RECEIPT DATE: 10-22-14 **ONSITE SEWAGE DISPOSAL SYSTEM** P 555283-A  
 INSTALLATION **PERMIT**  
 APPROVAL DATE: 5-29-13 *Kmw* **CONSTRUCTION** A \_\_\_\_\_

RE: Lot 2 Site Plan for BAT Installation  
Woodbine Crossing Subdivision

**PLOT PLAN**  
SITE PLAN FOR BAT TECHNOLOGY  
LOT 2  
**WOODBINE CROSSING**  
PLAT No. 20055  
715 WOODBINE CROSSING ROAD  
FOURTH ELECTION DISTRICT  
HOWARD COUNTY, MARYLAND  
SCALE: 1" = 30' JUNE, 2014

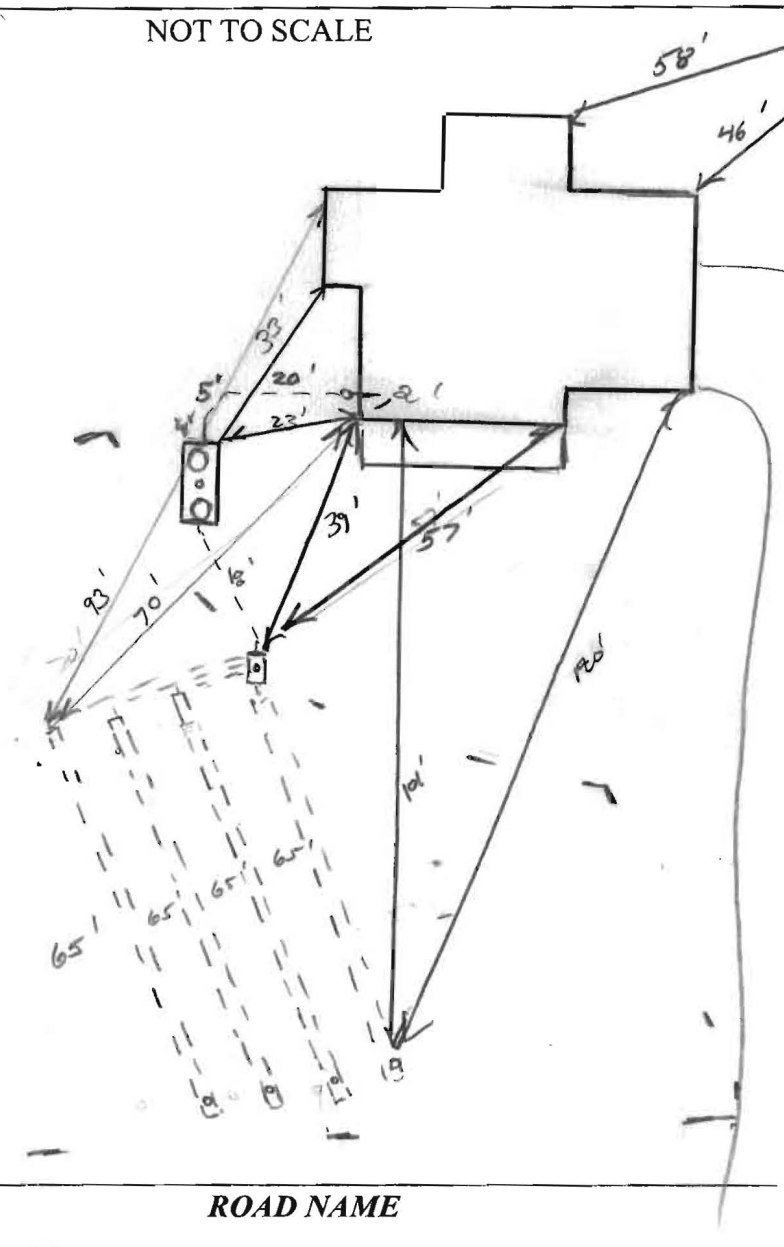
11/7/14 Elevations shot in field. Will not make gravity w/ 4' inlet invert to upper system. shot elevation @ start of second system. lower elevation. should be ok. Need to stake BAT location, re-shoot all trenches for second and third sep. systems (KW) SC

11/13/14 Trenches laid out BAT loc staked. OK to proceed w/ changes indicated. KW/SC

11/24/14 Inspections made by HD Tank set. working on trenches. 12/3/14 work completed on trenches. need BAT start-up for final approval (BB)

5/29/15 site visit for BAT start up. Pump/Blower working. system complete

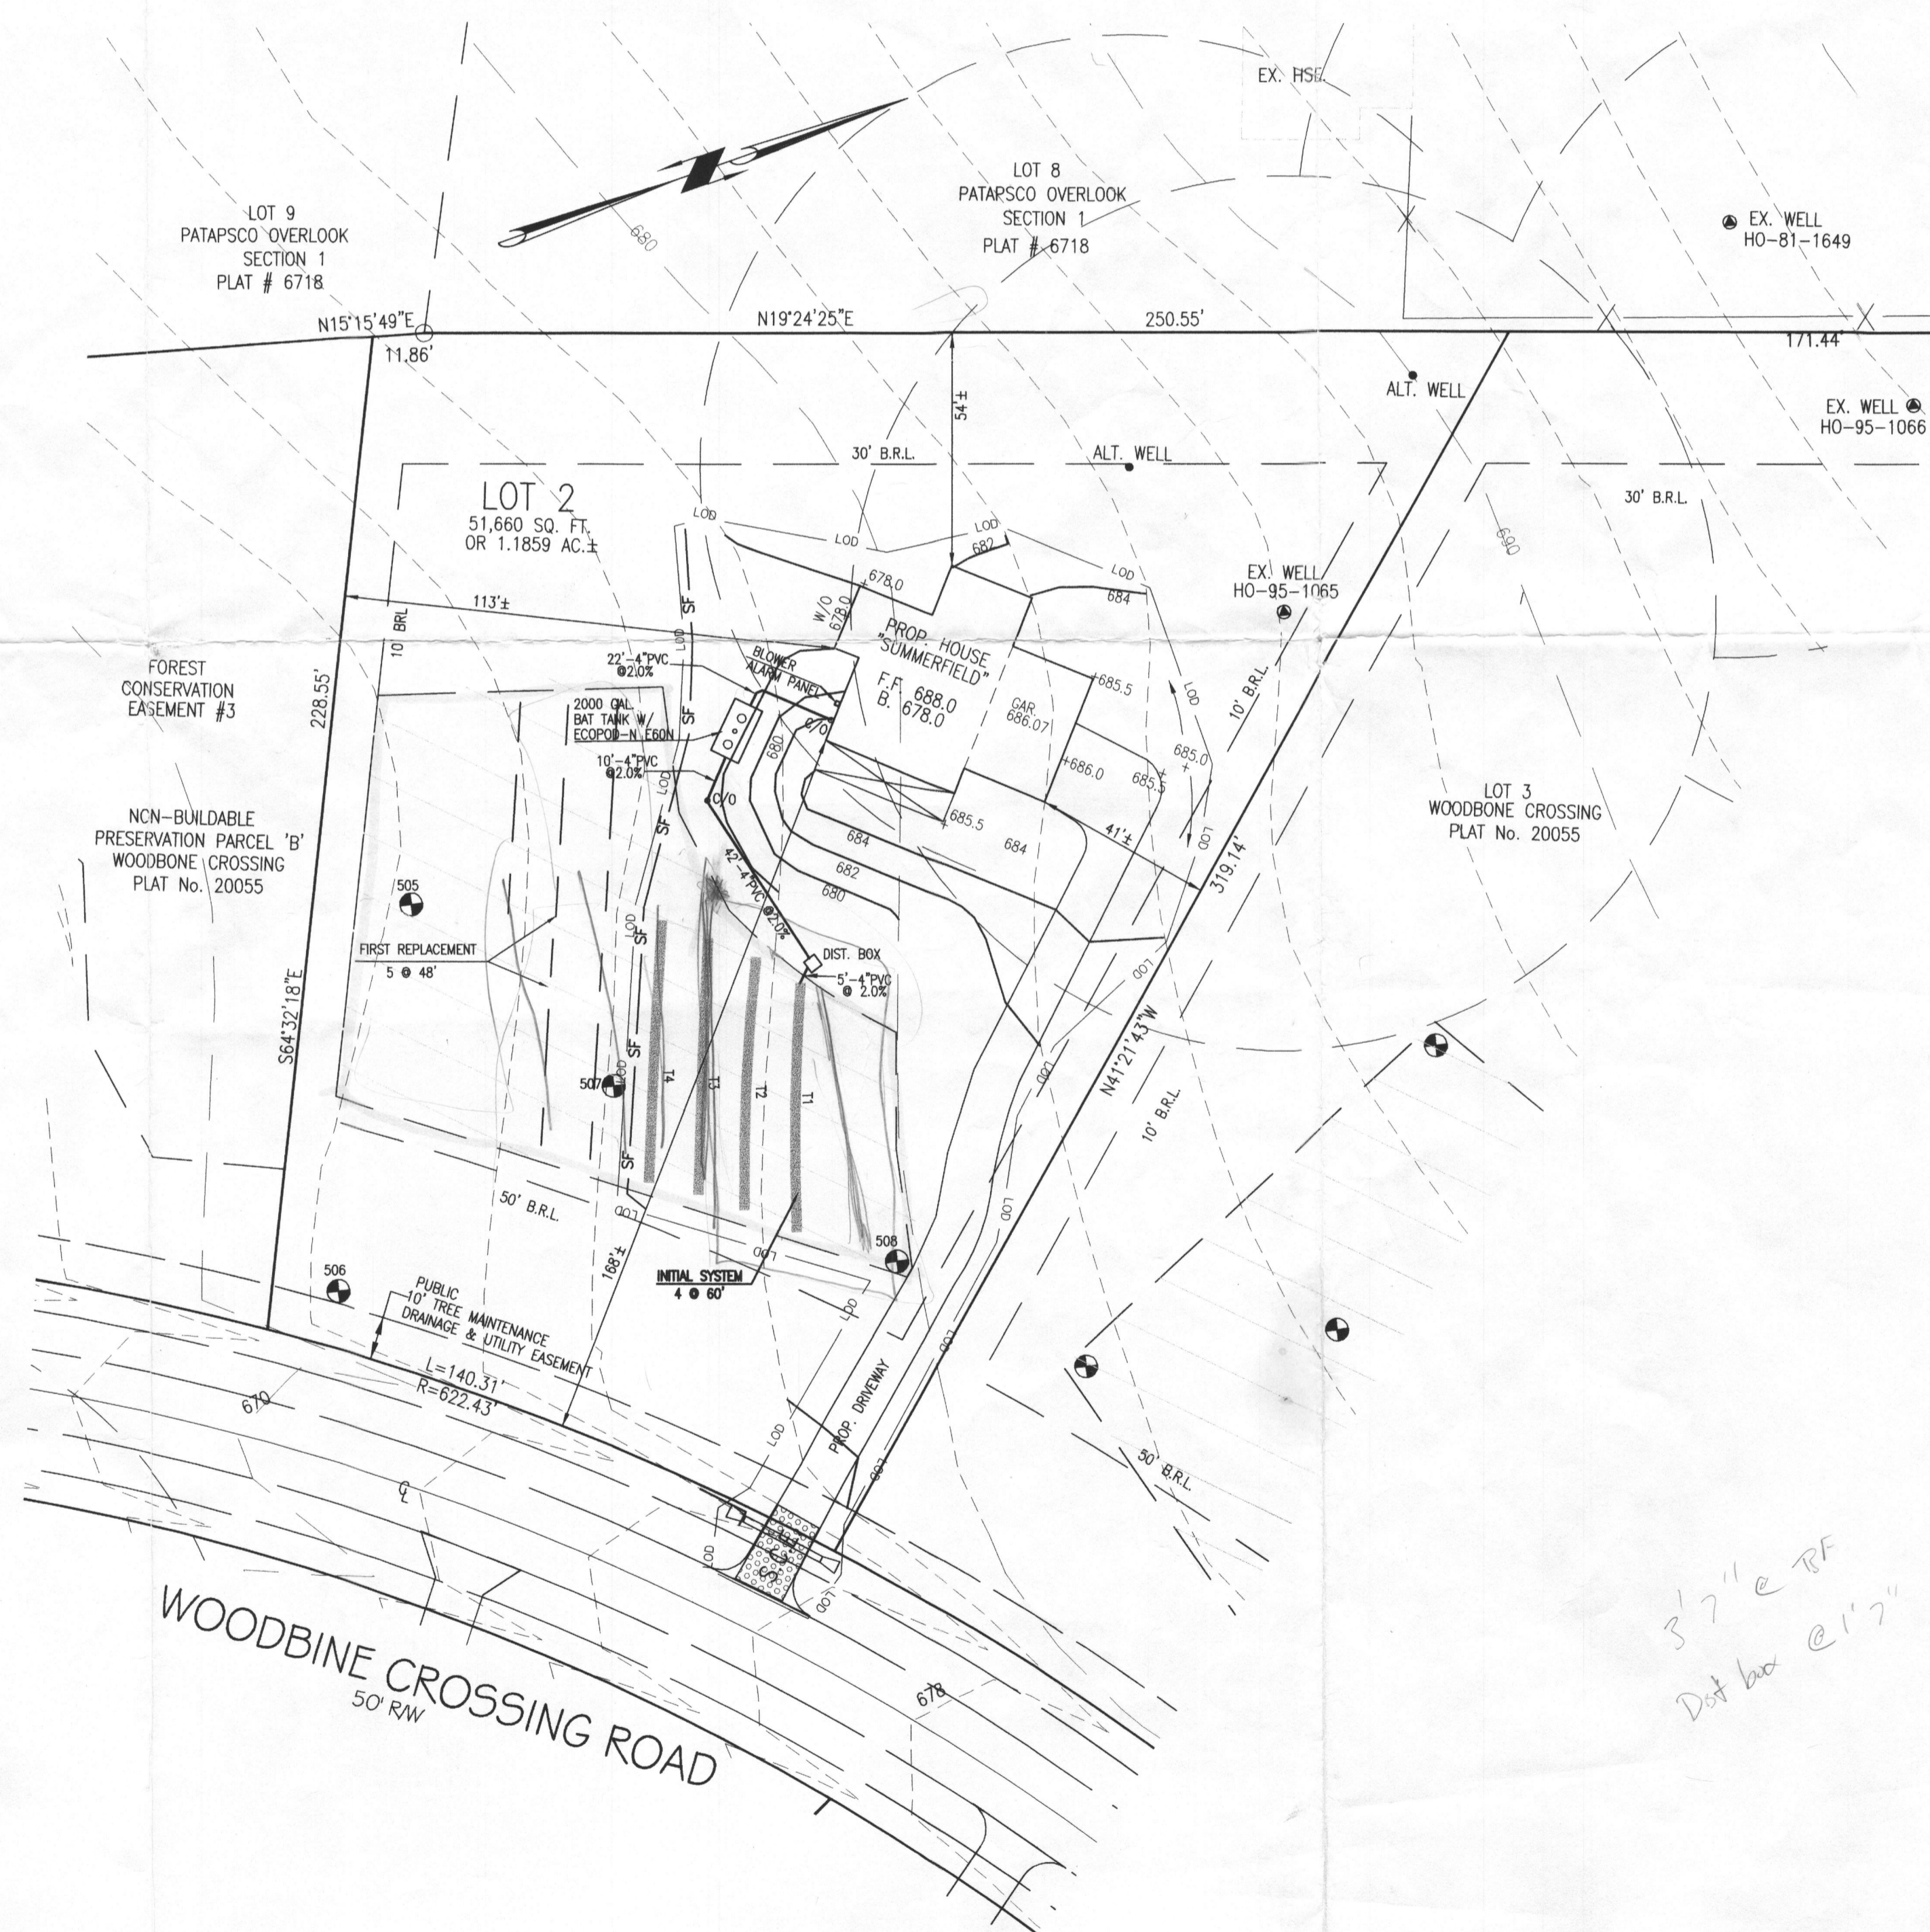
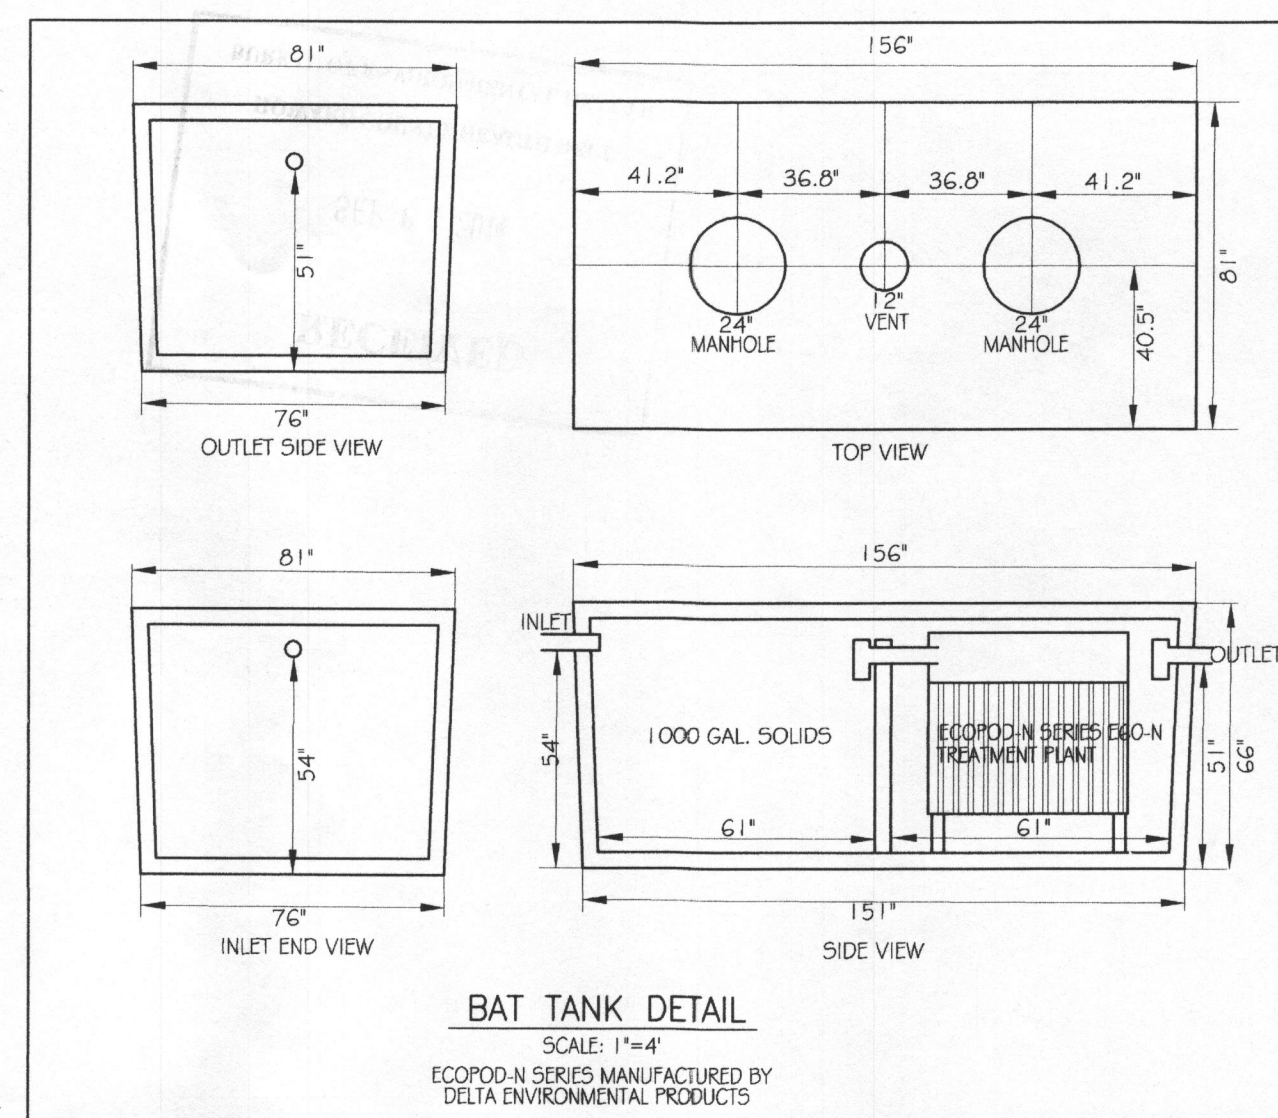
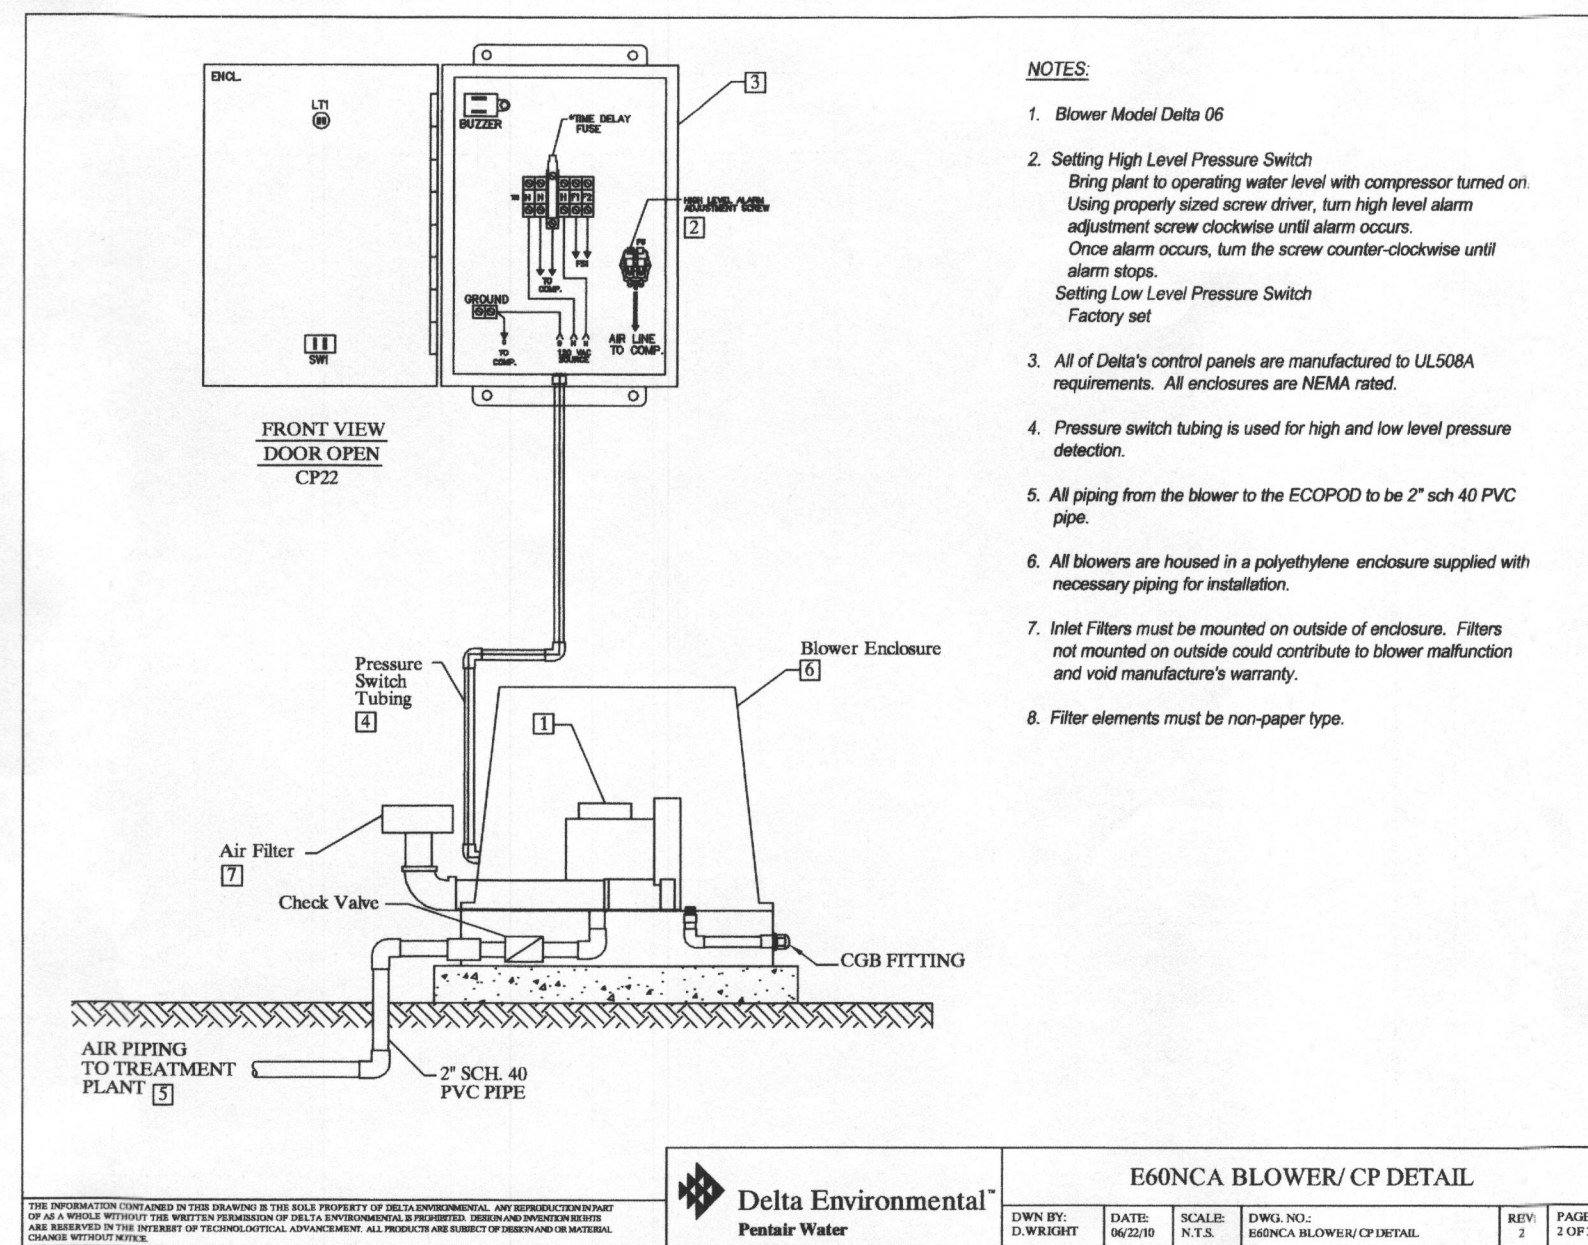
I've approved the revised BAT plan for WC lot 2. I was wondering why the tank was moved from the original proposed location. The only thing I don't like about the new spot is that in order to maintain fall, you are not using the upper portion of the reserve (wasting some space). I measured and saw that a 3<sup>rd</sup> system can fit below where you show the 2<sup>nd</sup>. For future reference, our priority is to use all available area the best we can. If we are not doing that, we need to see how 3 systems can fit in the area being used. I would prefer to see if it's possible in the field during installation to actually get the trenches a little higher up the hill so we don't waste space on this project. Thanks
